Consistency assessment report

Proposed changes between Eaton Road, Luddenham
and Littlefields Road, Luddenham

**The Northern Road Upgrade – Mersey Road,
Bringelly to Glenmore Parkway, Glenmore Park**

December 2018

Figure 2-1 Overview of proposed changes for the project

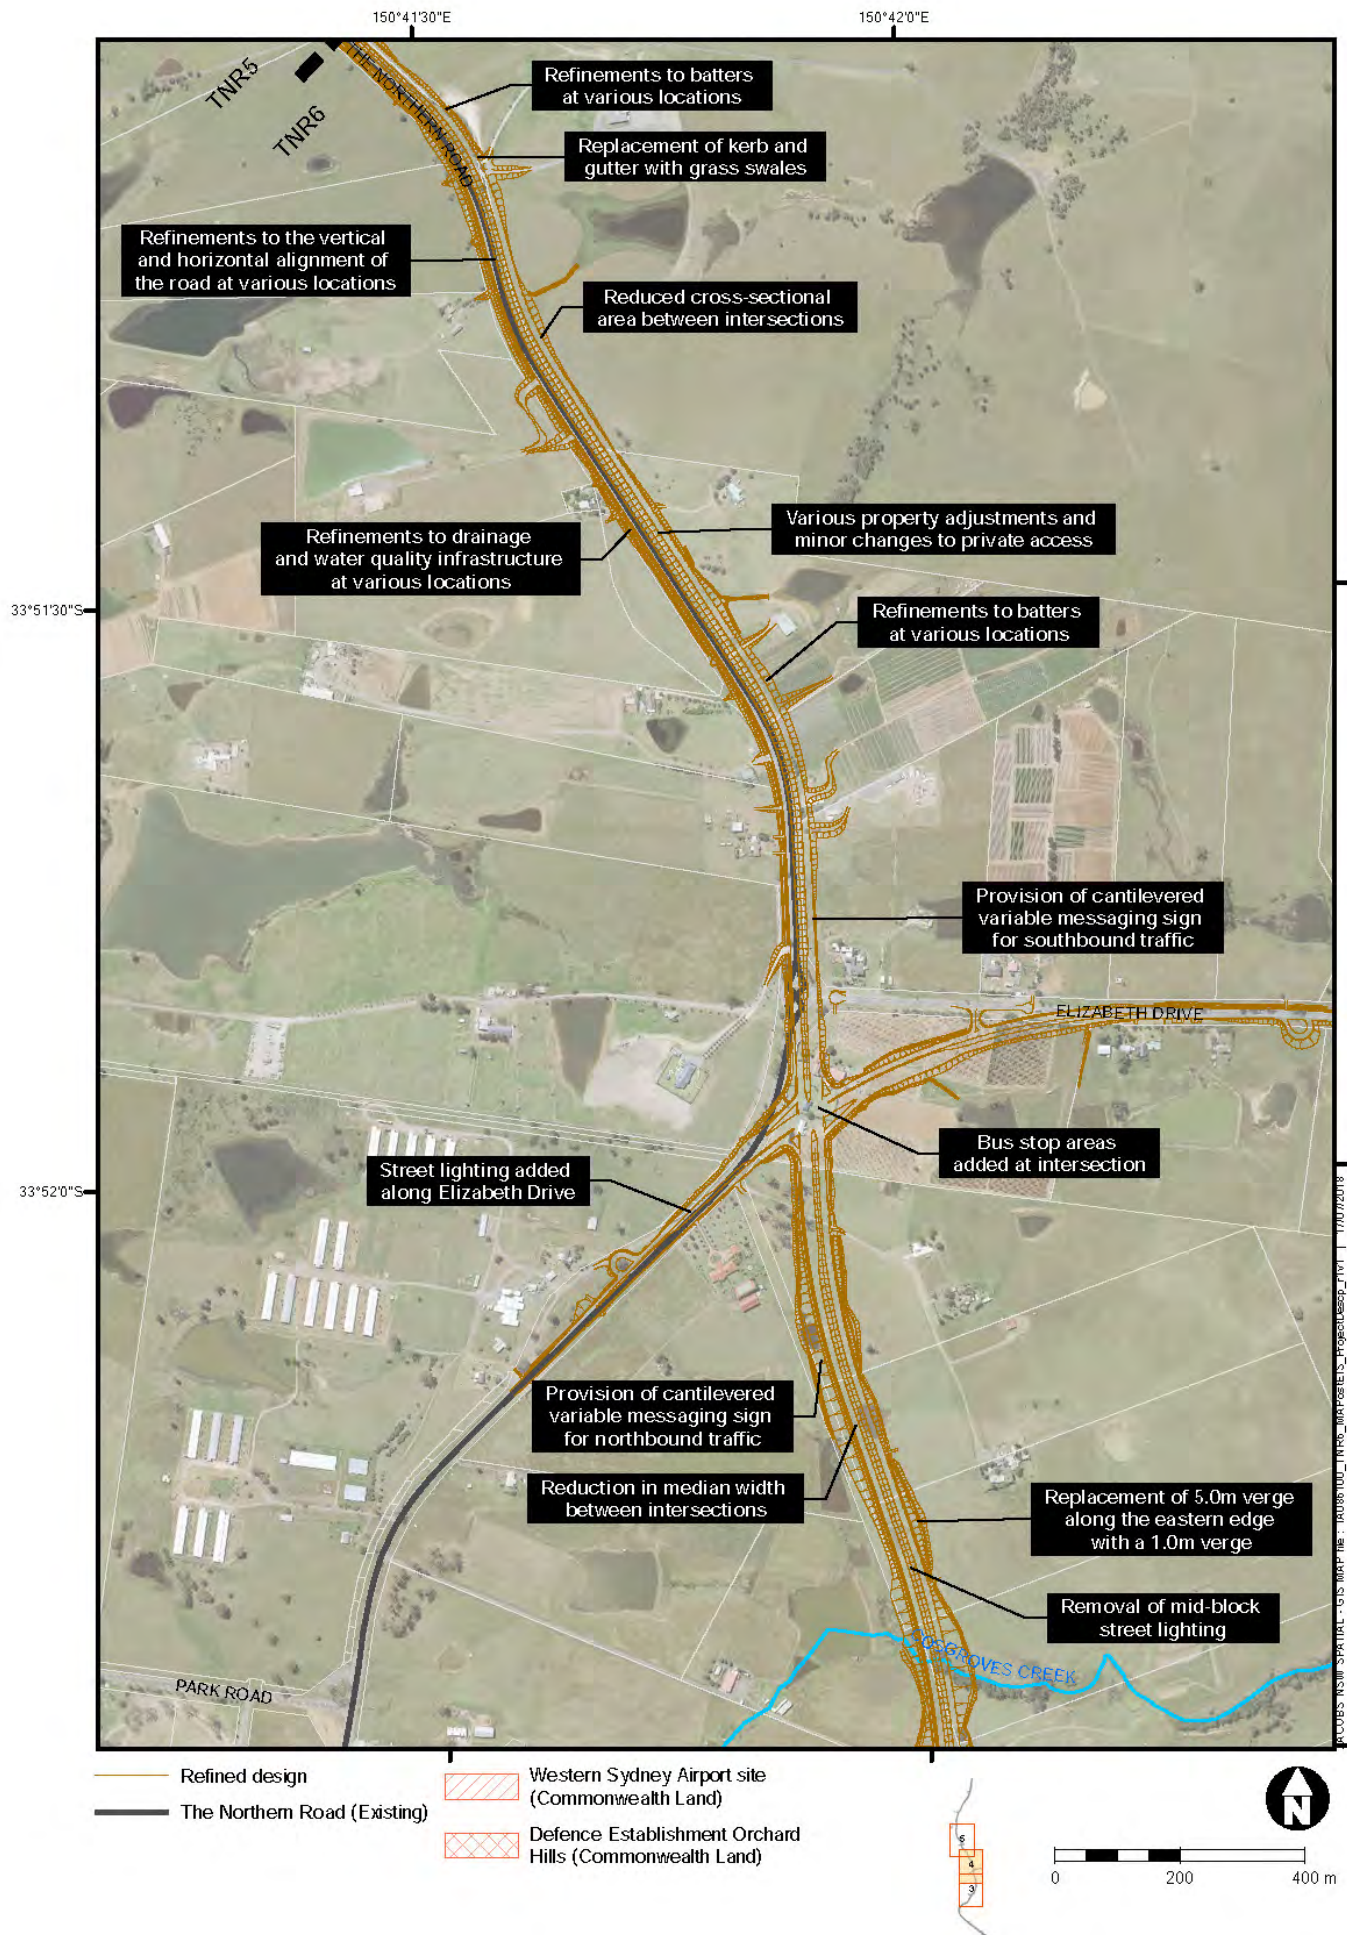
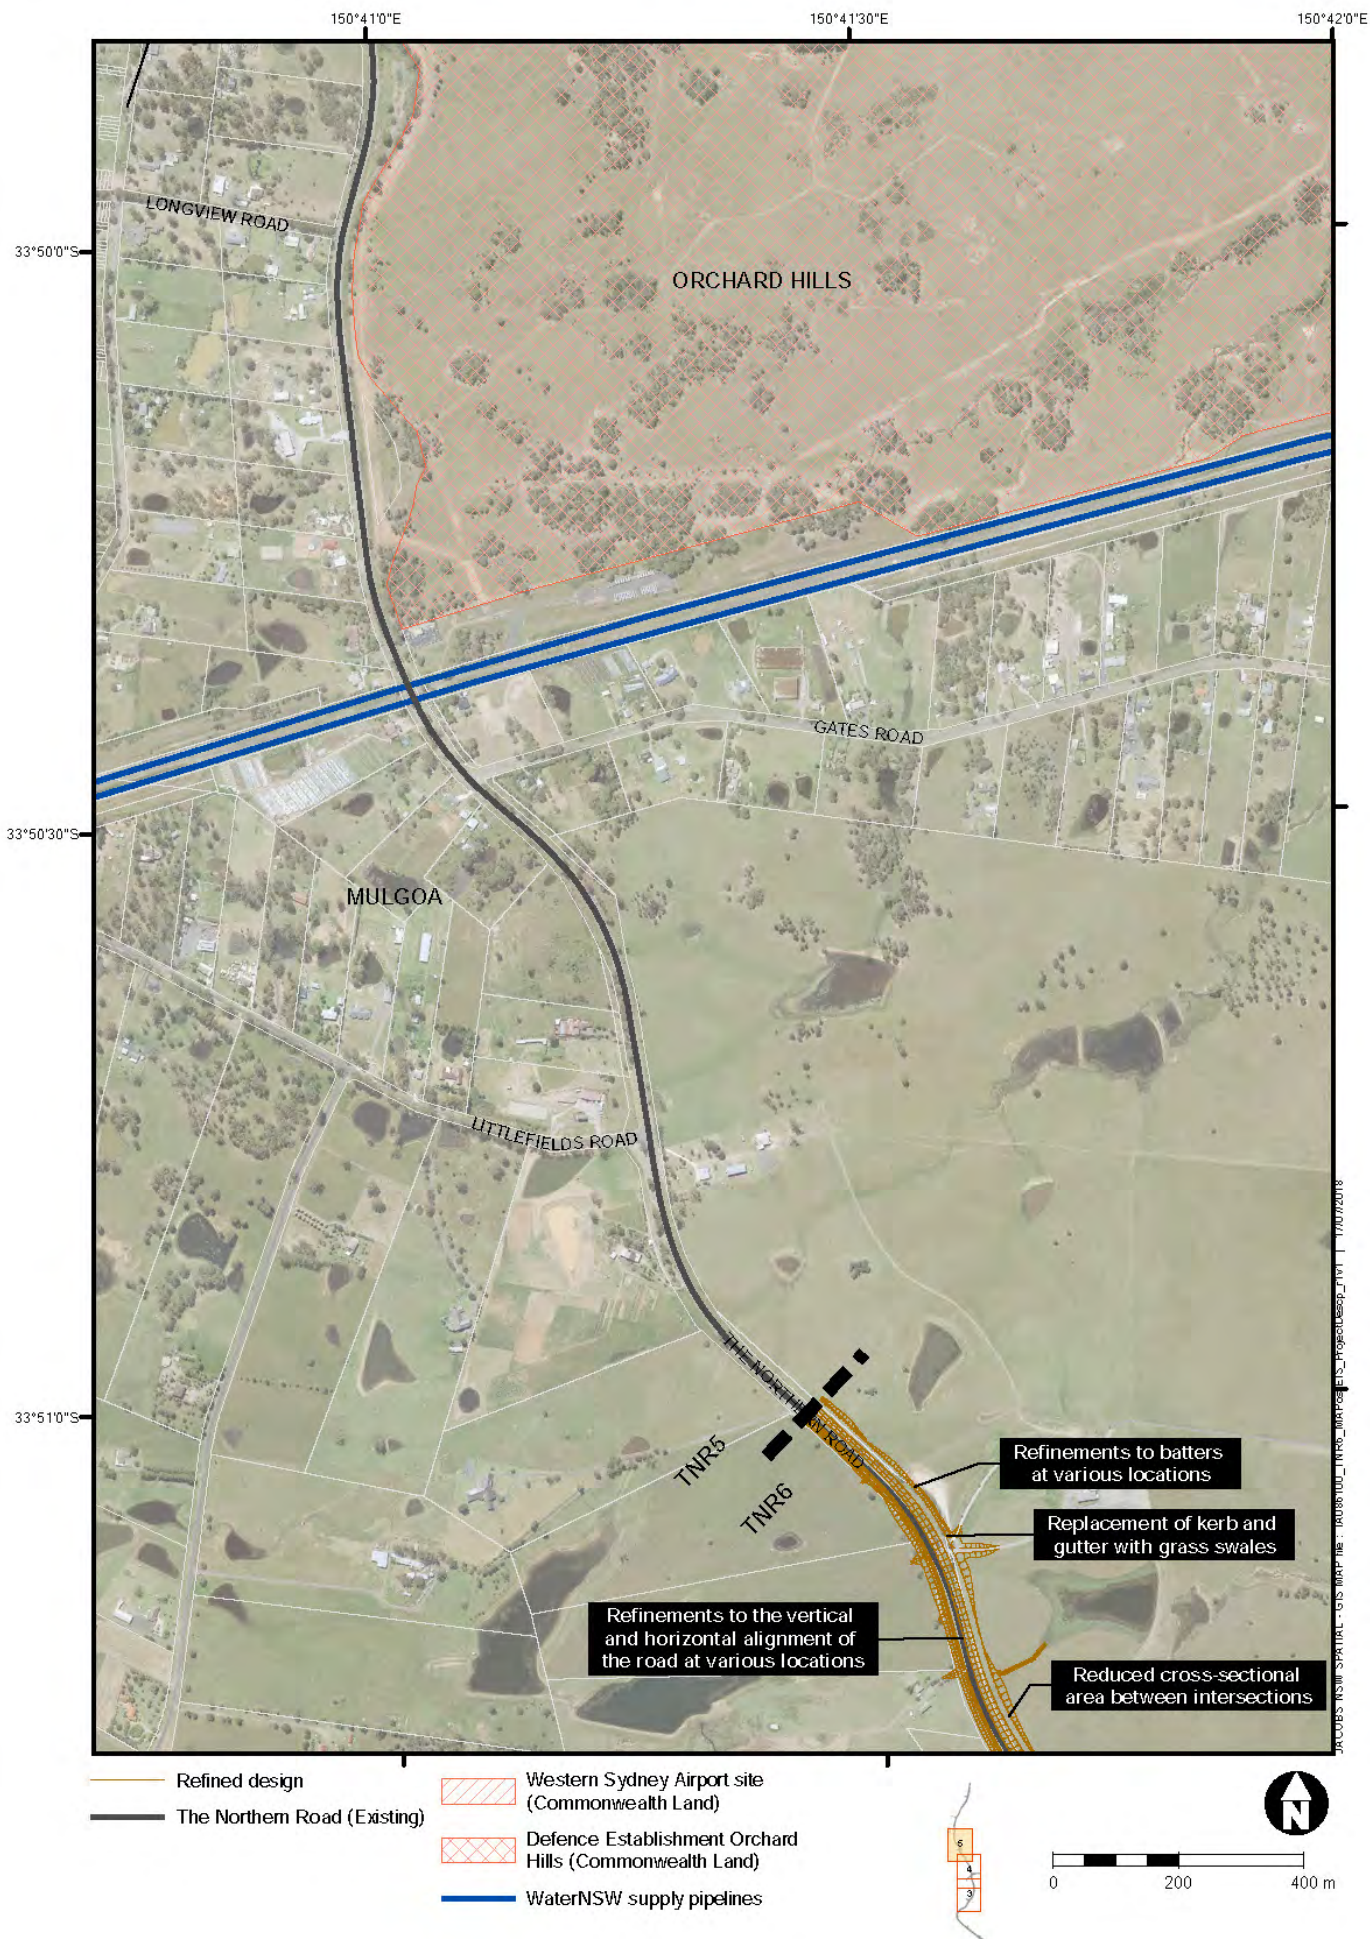
The project as described in the Division 5.2 Approval and the EPBC Approval is detailed in Chapter 5 of the EIS and amended in Chapter 4 of the SPIR and Final EIS. The proposed design changes to Stage 6 of the project are shown on Figure 2-1. For descriptive purposes within this consistency assessment, the design changes have been divided into:

- Minor design changes, generally consistent with the description of the project as described in the Division 5.2 Approval and the EPBC Approval
- Design changes that are not generally consistent with the description of the project as described in the Division 5.2 Approval and the EPBC Approval, thereby requiring a modification to the Division 5.2 Approval.

- Replace kerb and gutter with grass swale, except at footpath locations near Adams Road and Elizabeth Drive intersections
- Changes to drainage structures (pit, pipes, culverts, swales) to suit horizontal and vertical geometry

- Other minor refinements to the vertical and horizontal alignment of the road at various locations
- Cut and fill batter slopes revised from 1:4 to 1:3 in most places. Benching added to high cuts between chainage 6320 – 6620

- Removal of street lighting mid-block
- Street lighting added for turning heads along Elizabeth Drive
- Bus stop areas added on north-bound and south-bound lanes at Adams Road and Elizabeth Drive intersections

Roads and Maritime proposes to modify the Division 5.2 Approval to replace the approved twin bridges over Adams Road with an at-grade signalised intersection.
